City of San Antonio

Re: **The Orchard**

MDP # 021-08

The Development Review Committee has reviewed **The Orchard** Master Development Plan **M.D.P. # 021-08**. Please find enclosed an accepted and signed copy for your files. However, please note the following conditions:

THE ORCHARD
 SAN ANTONIO, TEXAS
MASTER DEVELOPMENT PLAN

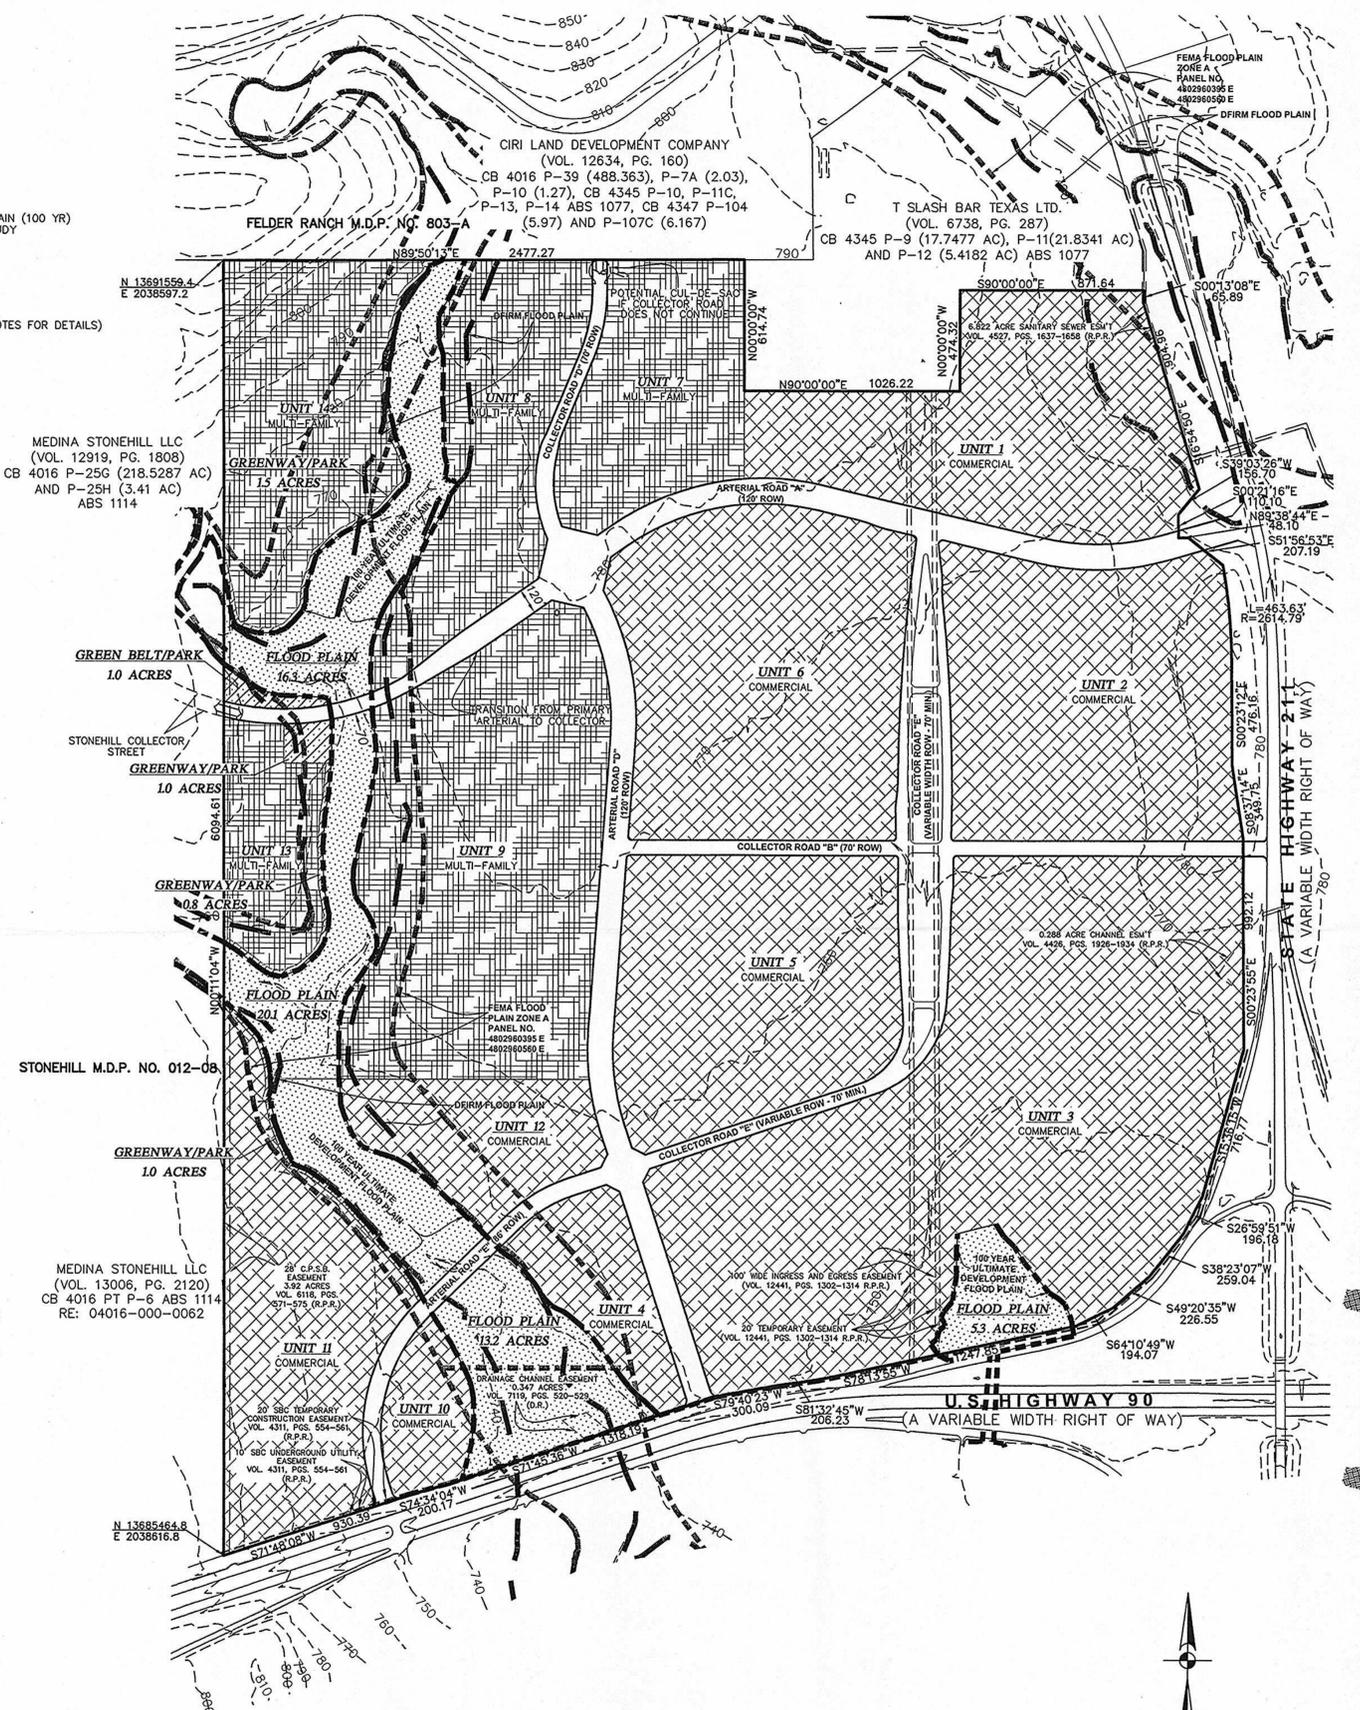
In consideration of public safety and convenience, excessive grades by reason of topography should be avoided in street layouts and arrangements. All platting shall comply with the Unified Development Code (UDC), Master Plan, Major Thoroughfare Plan, and all applicable regulations for the City of San Antonio. It will be expected that all of the property depicted in your Master Development Plan to include floodplains, drainage areas, and open space shall be platted. It is suggested to work closely with the school district, so they can plan accordingly. Any access and R.O.W. issues along state facilities will need to be resolved with the **Texas Department of Transportation (TXDOT)**. For information about these requirements you can contact TXDOT at 615-5814.

- Coordinate with the Texas Department of Transportation for improvements along SH 211 and US Highway 90.
- Right and left turn lanes may be required and should be designed according to TxDot standards. Any mitigation along US 90 and SH 211 should be coordinated with TxDot.
- TxDot will determine access points along US 90 and SH 211.
- Traffic controls shall be warranted as per the Texas Manual on Uniform Traffic Control Devices and approved by Bexar County and TxDot.

- The Texas Sites Atlas indicates that no archaeological sites have been previously identified within the above referenced property. However, the project area lies between the East Branch Big Sours Creek and Lucas Creek and there is a **high probability** that the property may contain sites, some of which may be significant. The project area is within the known 11 league grant for the Ranch de San Lucas, one of two 18th century Spanish ranchos for the Mission San Jose y San Miguel Aguayo. Thus, before any work that might affect any sites is begun, we recommend that a qualified professional conduct an archaeological investigation of the property. The investigation should be performed according to Archeological Survey Standards for Texas, and any previously identified sites should be reexamined and reevaluated, if any.
